Project
Replacement Dwelling at 24 Wedgwood Lane, Biddulph, ST8 6RL

Title
Typical Bat Mitigation Ridge Detail

Date	Dec 2019	Drawn	SS
Scale @A3	1 : 5	Checked	-
Project No	Drawing No.		
18-063	AA(2)201	Rev	1

Typical Bat Mitigation Ridge Detail - Plain Tiles
1 : 5

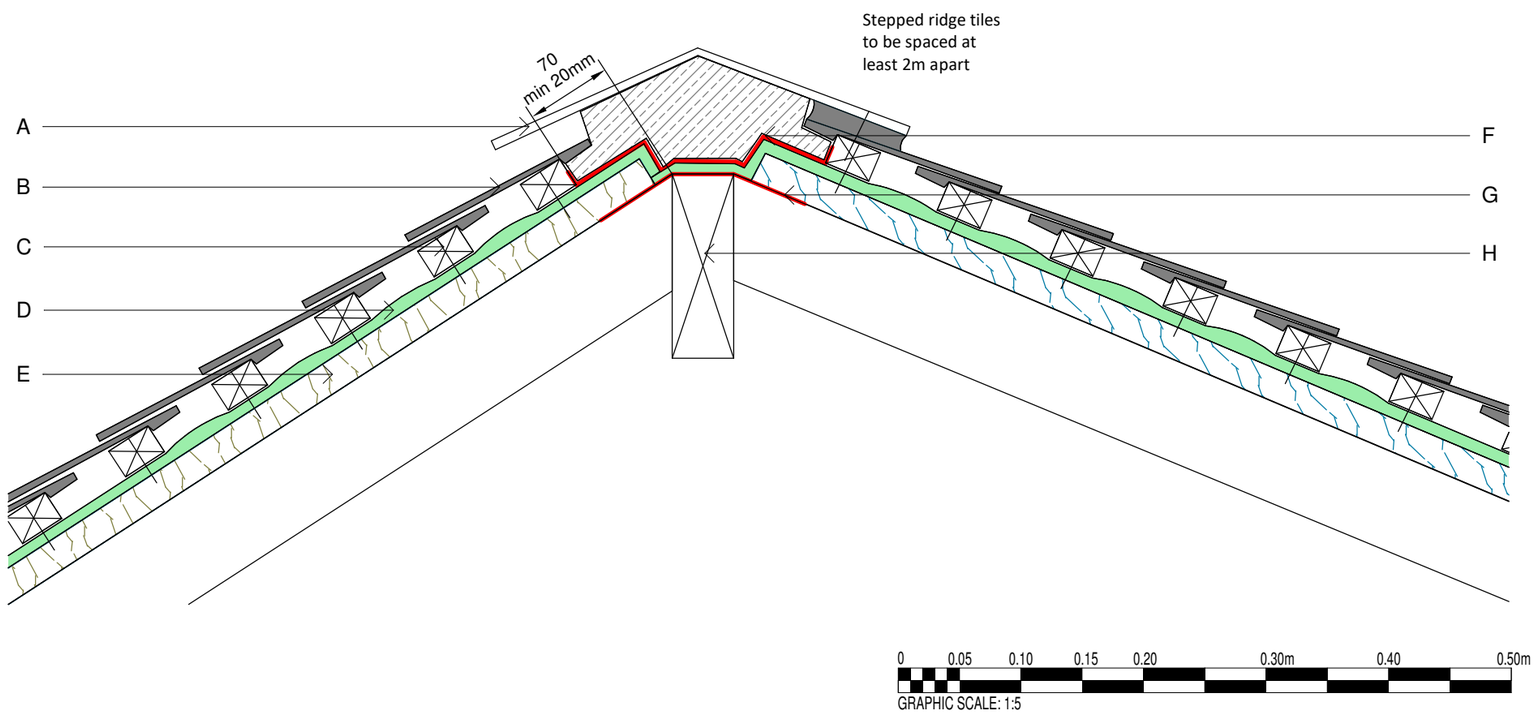
Rev.	Drawn	Comments	Date
1	SS	Detail revised from fibre cement slate roof to plain tile roof.	16/06/20
